# Proposed Amendments to the Eau Claire Area Redevelopment Plan

1. The Eau Claire Area Redevelopment Plan attached to and forming part of Bylaw 2P95, as amended, is hereby further amended as follows:

Figure 5

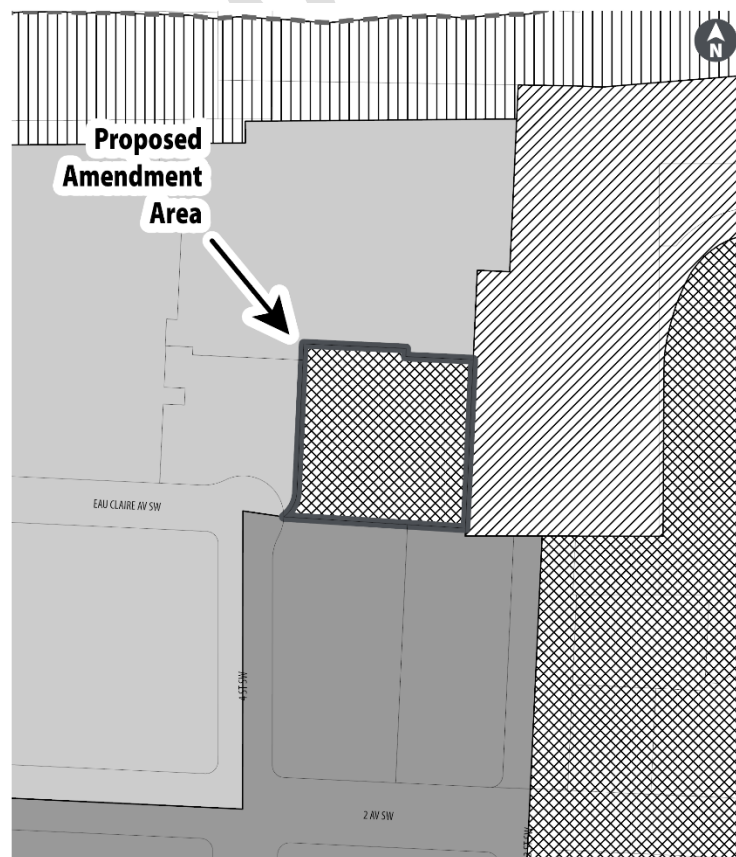
(b) Amend the existing Map entitled ‘Figure 5 Generalized Land Use’ by changing 0.40 hectares ± (0.99 acres ±) located at 101 – 3 Street SW (Plan 8610839, Block 1, Lot 15) from ‘Commercial’ to ‘Mixed Use’ as generally illustrated in the sketch below:

Figure 6

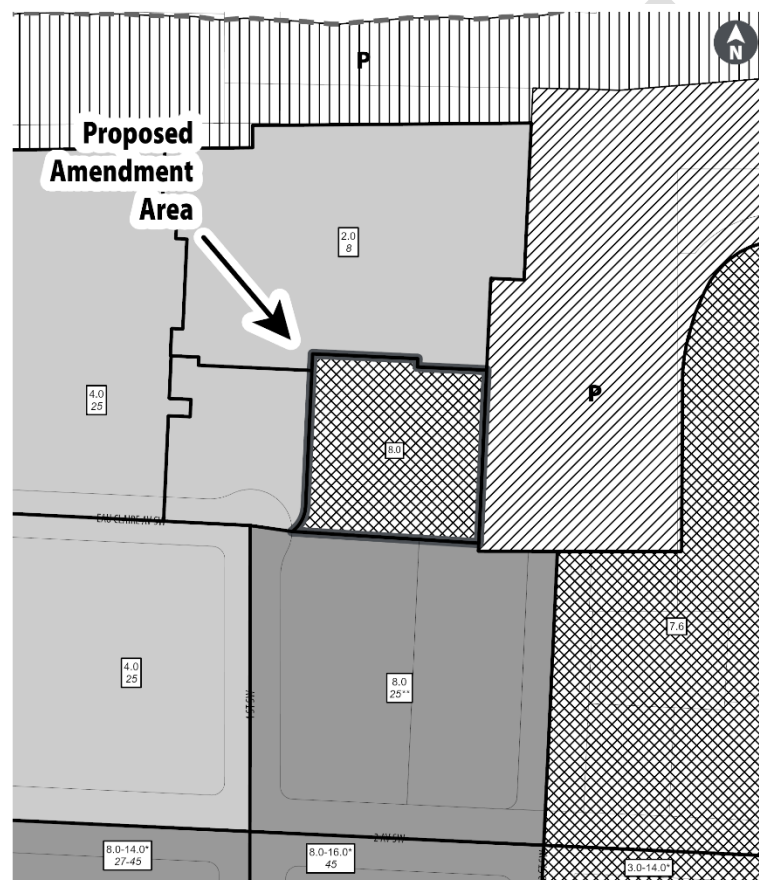
- (c) Amend the existing Map entitled 'Figure 6 – Potential Major Land Uses, Densities and Building Heights' by changing 0.40 hectares ± (0.99 acres ±) located at 101 – 3 Street SW (Plan 8610839, Block 1, Lot 15) from 'Commercial' with 'Institutional' to 'Mixed Use' with a maximum floor area ratio of 8.0, as generally illustrated in the sketch below:
